HISTORIC AND DESIGN REVIEW COMMISSION

HDRC CASE NO: 2023-322
ADDRESS: 506 STIEREN
LEGAL DESCRIPTION: NCB 2966 (STIEREN STREET REPLAT), BLOCK 1 LOT 18
ZONING: RM-4, H
CITY COUNCIL DIST.: 1
DISTRICT: King William Historic District
APPLICANT: IDOWU NTOKA/ION HOMES AND RESORT USA LLC
OWNER: IDOWU NTOKA/ION HOMES AND RESORT USA LLC
TYPE OF WORK: New construction of two, 2-story duplex structures
APPLICATION RECEIVED: October 24, 2023
60-DAY REVIEW: December 23, 2023
CASE MANAGER: Rachel Rettaliata

The applicant is requesting a Certificate of Appropriateness for approval to construct two, 2-story duplex structures on the lot addressed 506 Stieren.

The Site Plan

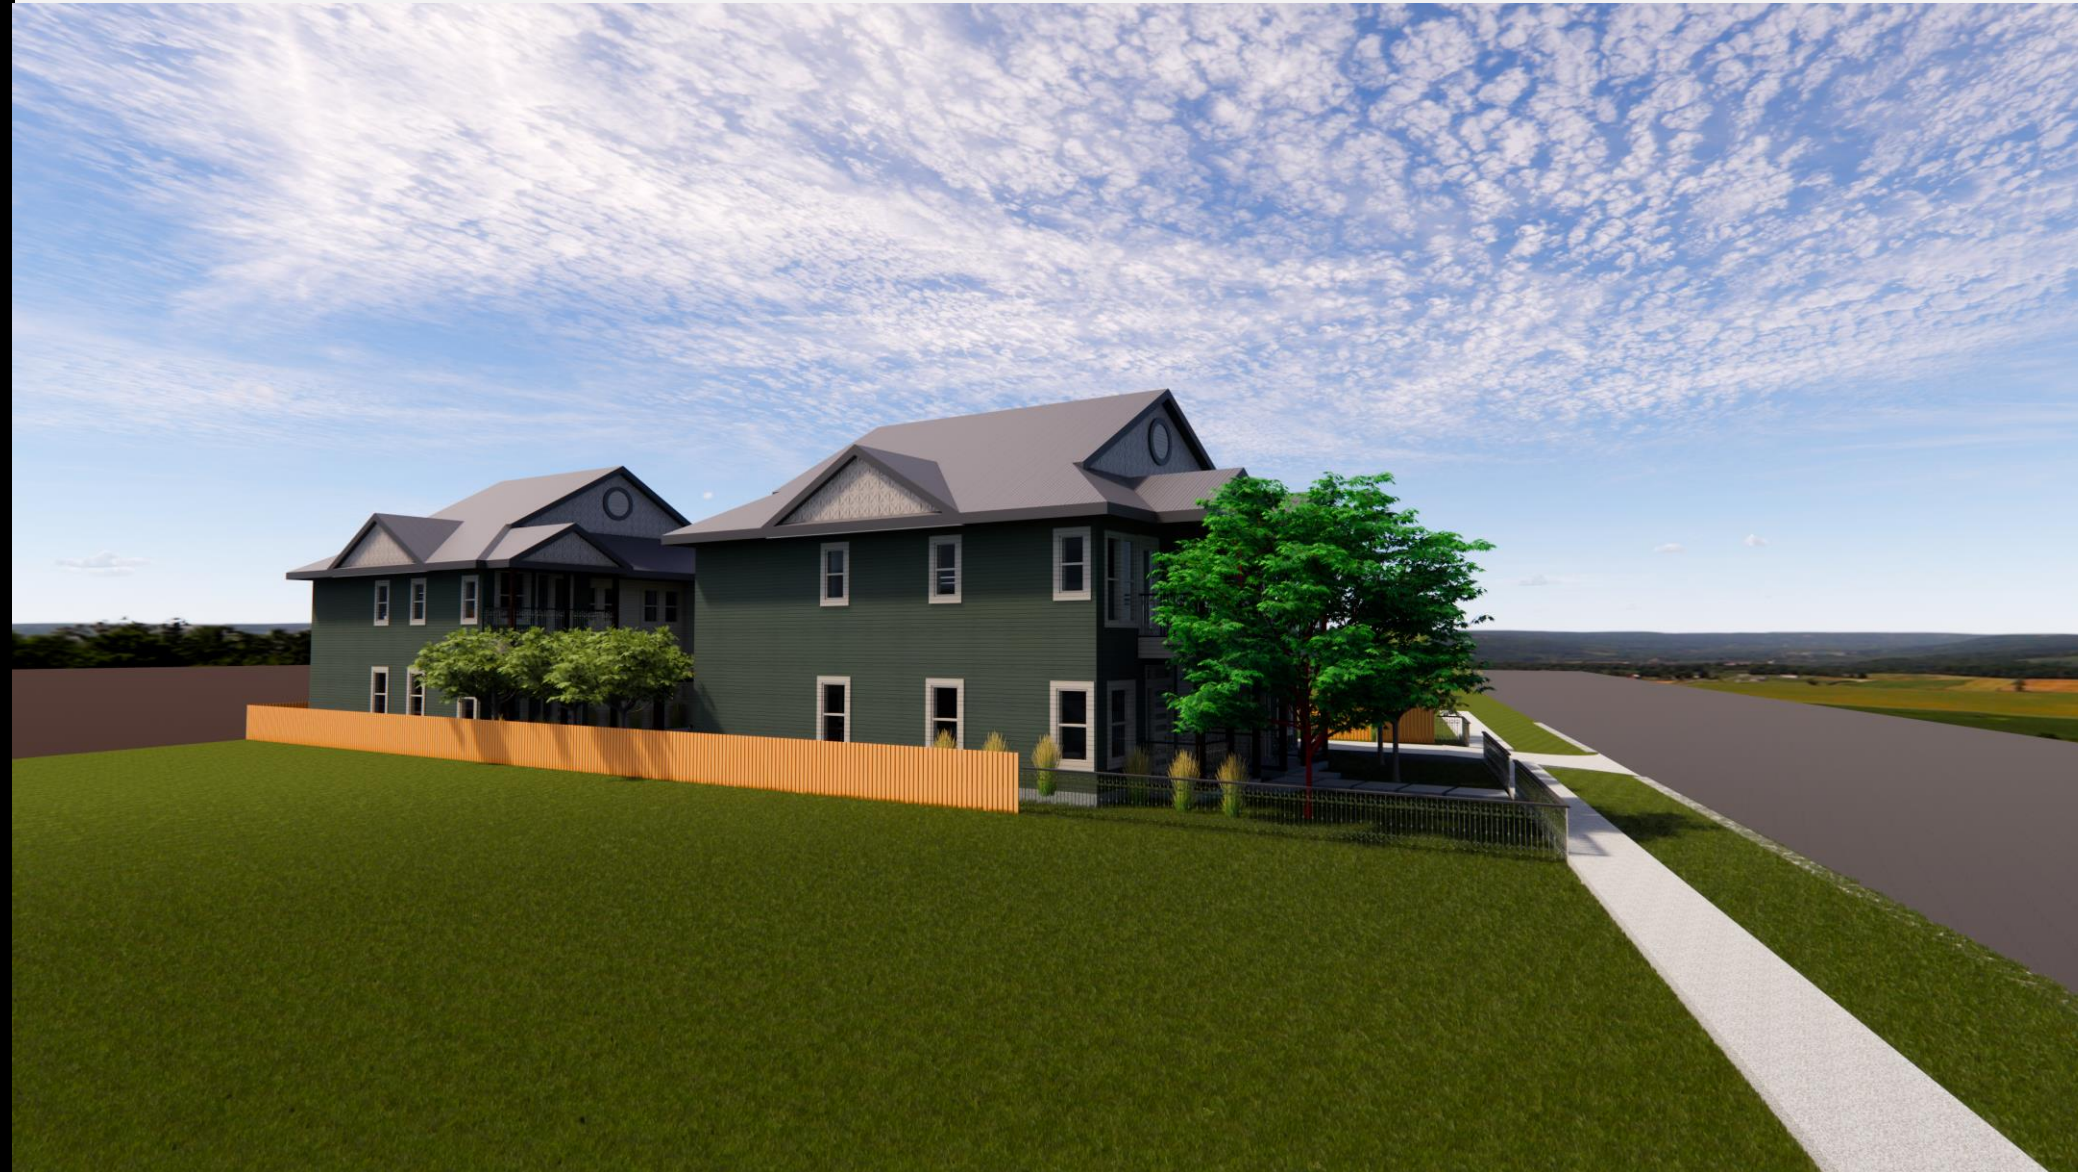
- m. DRIVEWAY AND PARKING – The applicant has proposed to install a shared common drive along the western edge of the property and a shared parking area between the two structures, at the rear of the property, and along the west side of the property. The applicant has proposed to install metal carport structures at parking spaces 2 & 3 and spaces 4 & 5. Guideline 8.F.iv for Medium-Density and Multifamily states that a single, 10-foot driveway at one street frontage is recommended. Projects should first attempt to utilize historic curb cuts where extant. Additional entry points may be considered where there is alley access. The addition of driveways should not confuse or alter the historic development pattern. Do not introduce wide, shared driveways that appear visually similar to a street. Staff finds that wood or wood-look carports would be most appropriate and finds that the applicant should submit updated material specifications and an updated site plan showing the locations of the proposed carports, along with dimensions for the proposed driveway apron and driveway throat.

- n. MECHANICAL EQUIPMENT – The applicant is required to comply with the Historic Design Guidelines related to equipment location and screening.
- o. LANDSCAPING AND HARDSCAPING – The applicant has submitted a site plan showing the proposed hardscaping, including a concrete apron and paving along the western side of the property, grass pavers in the parking areas, greenspace in the front and rear yard, and a front paver walkway from the sidewalk to the front entry oriented toward Stieren, and a paver entry in front of Unit 2. Guideline 8.A.iii for Medium-Density and Multifamily states that as multiple buildings are proposed for a site, they should be separated and scaled in a manner that preserves open space consistent with the established context area. For example, if the context area predominately consists of a primary structure separated from a rear accessory structure by a common distance, then the proposed development should follow a similar pattern. Preserved open space may be used for common areas, amenity space, or uncovered parking. Staff finds the proposal generally appropriate but finds that the applicant should install a fully concrete walkway in lieu of the proposed paver walkway.

- vii. That the applicant installs a fully concrete walkway in lieu of the proposed paver walkway based on finding o. The applicant is required to submit an updated site plan to staff for review and approval prior to the issuance of a Certificate of Appropriateness.

RESPONSE: DONE. Design updated with Pervious pavers and increased green space

1 FIRST BLDG FRONT ELEVATION
3/16" = 1'-0"

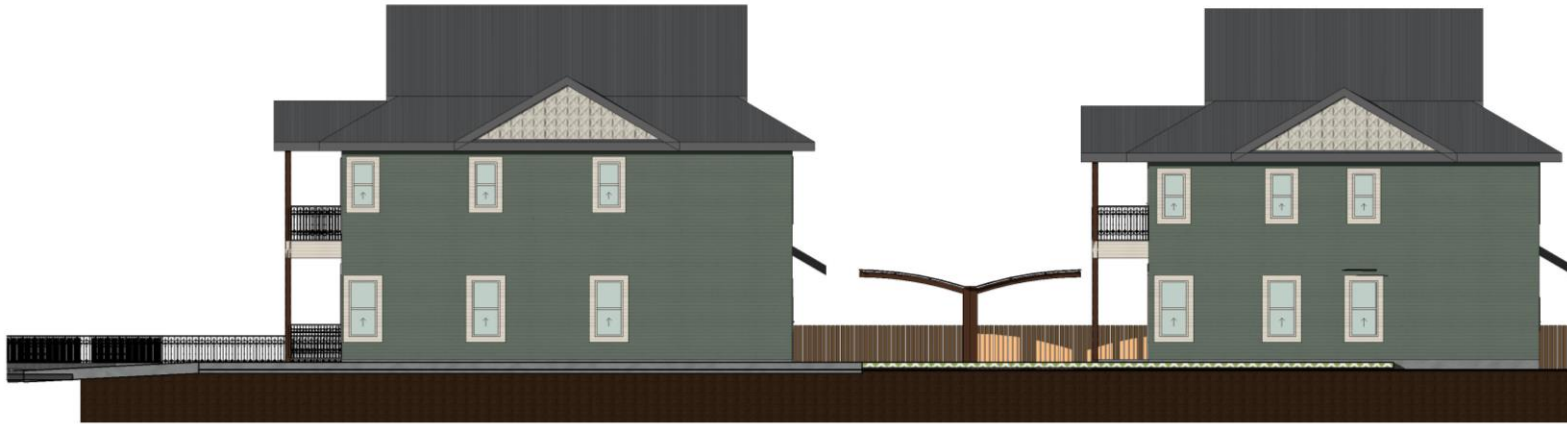
- h. **ROOF FORM** – The applicant has proposed to install a modified Dutch gable composition shingle roof featuring front gable detailing and front gable porch roofs on the front façade, with side gables. Guideline 8.D.i for Medium-Density and Multifamily states that projects should incorporate roof forms—pitch, overhangs, and orientation—that are consistent with those found in the established context area. Flat or shed roofs are not typical of primary structures in San Antonio's residential historic districts and should be avoided. Staff finds the proposal generally appropriate.

- i. **ENTRANCES & PORCHES** – The applicant has proposed two central double-height front porches as entrances on Unit 1, facing Stieren, and two flanking double-height porches as entrances on Unit 2, facing Stieren and oriented toward the rear elevation of Unit 1. Per the Guidelines for New Construction, the primary façade of new buildings should be in keeping with established patterns in terms of porches, entrances, orientation, and setbacks. Additionally, Guideline 8.D.ii for Medium-Density and Multifamily states that traditional front porch depths and forms should be utilized to establish a pedestrian scale along the street frontage. Porch designs should be similar in dimension and form as those found on historic buildings within the established context area. Staff generally finds the front setback and porch design to be consistent with the Guidelines.

- ii. That the applicant installs traditionally sized windows in lieu of the proposed slider windows on the rear elevations based on finding j. The applicant must submit updated elevation drawings to staff for review and approval prior to the issuance of a Certificate of Appropriateness.

- x. That the porch elements are painted the same color.
 - xi. That the railings and fence styles should be simplified and less ornate.
 - xii. That the door styles are compatible with the style of the structure.

RESPONSE: DONE. Building roof plane has been updated to be consistent with established context area.

1 RIGHT ELEVATION
3/16" = 1'-0"

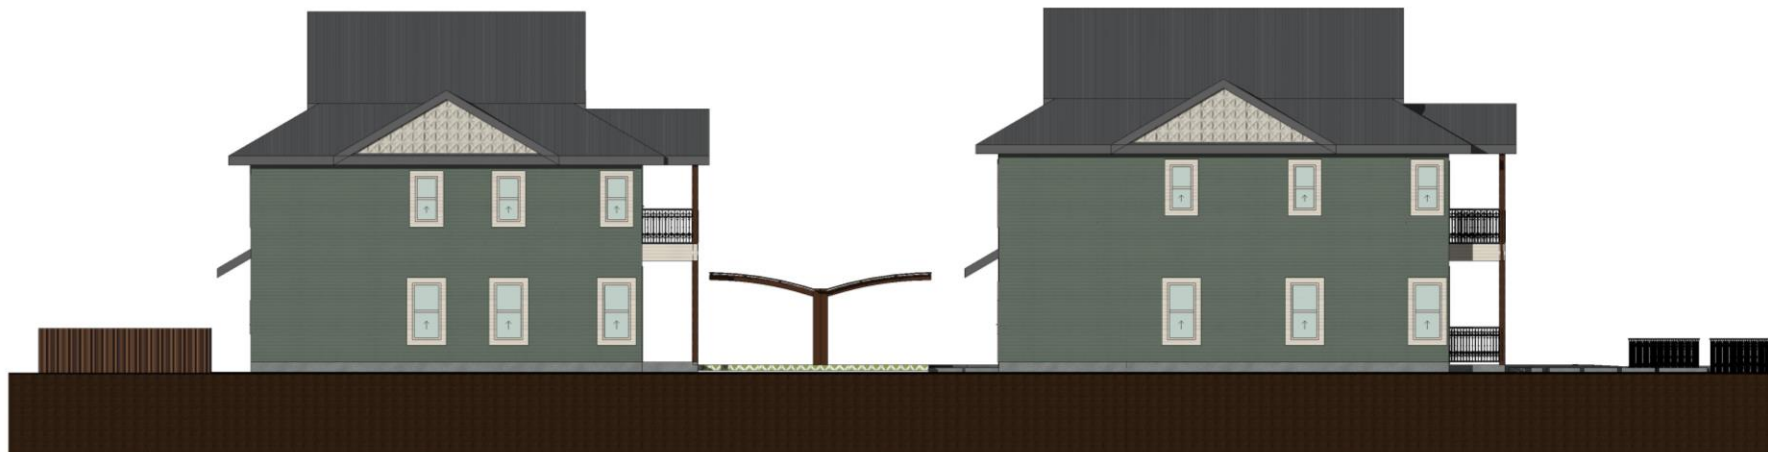
- xiii. That windows are relocated away from corners on the left and right side elevations.
- xiv. That the windows have a 3-to-1 vertical proportion to match windows predominantly found in the King William Historic District.

- xv. That the gable attic vents are modified to be rectangular to be in keeping with gable attic vents found in the King William Historic District.
- xvi. That the applicant shifts the side gables to be centered and composed with the windows below.

Porch Column

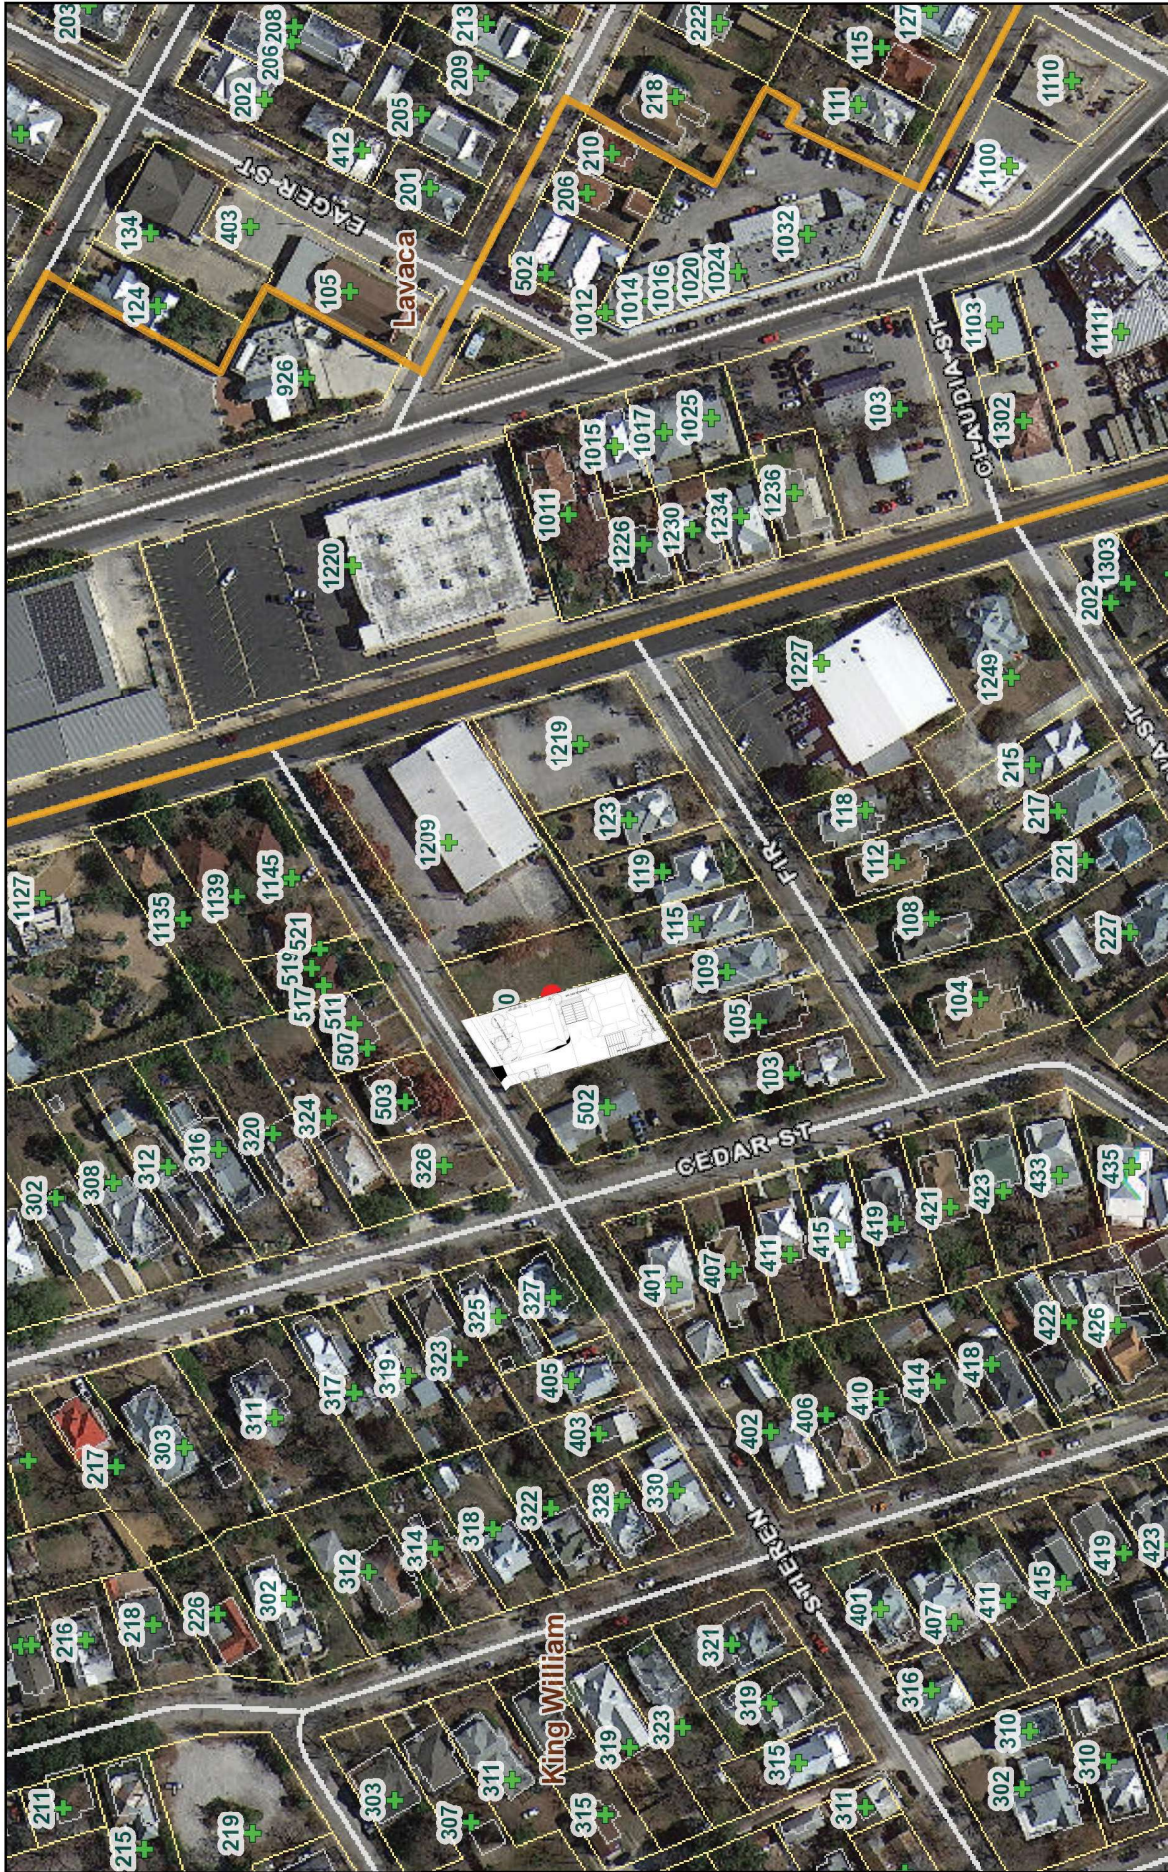
lites, and rear door awnings. Staff finds the proposal generally appropriate but finds that the proposed wood columns should be no wider than 6" square, feature both capital and base trim and chamfered corners.

- iii. That the applicant installs fully wood porch columns the proposed that are no wider than 6" square and feature both capital and base trim and chamfered corners. The applicant is required to submit final material specifications for the porch columns to staff for review and approval prior to the issuance of a Certificate of Appropriateness based on finding k.
